Disability Access Report

Proposed Seniors Living  
16-26 Friend Street  
MERRYLANDS NSW

For: Crawford Architects  
Ref: LP\_19008

Figure 4 | Local Shops to Coleman Street

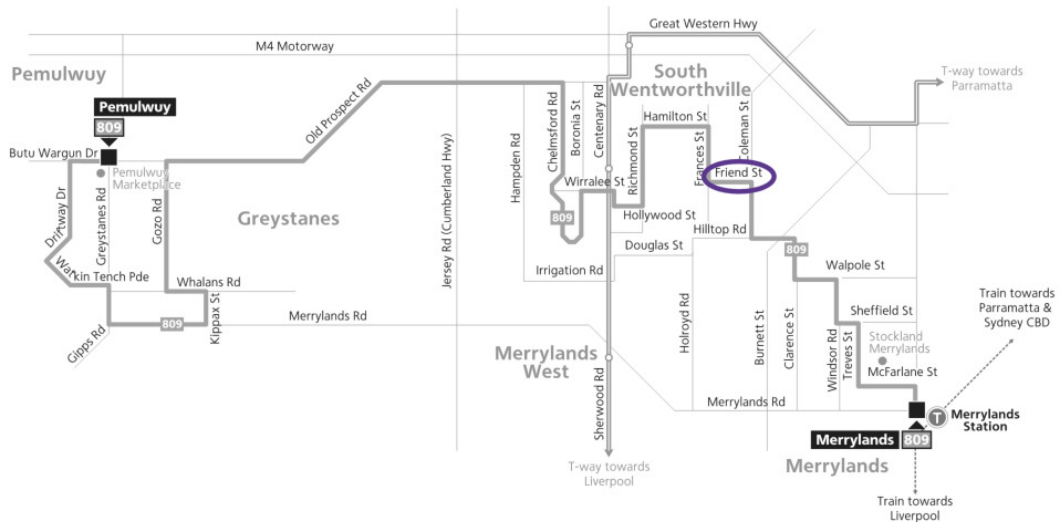
We note that local shops are within 200m of the development site on the corner of Friend and Coleman Street. A convenience store, fruit shop, butcher and pizza shop are provided in this location.

Figure 7 | Existing Footpath to Front of Site

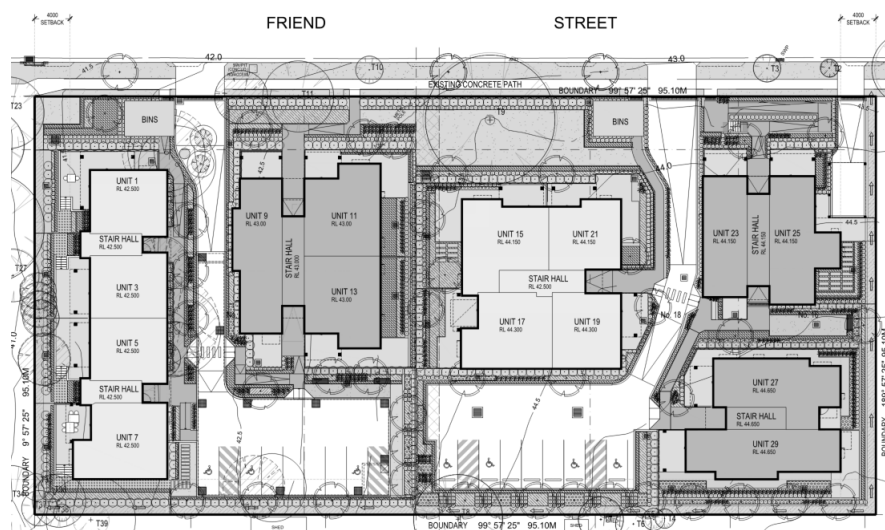
The proposed development meets the intent of this Clause with links to public transport and local shops via the existing footpath infrastructure. The footpaths provide obvious routes to the bus stops and are in good condition.
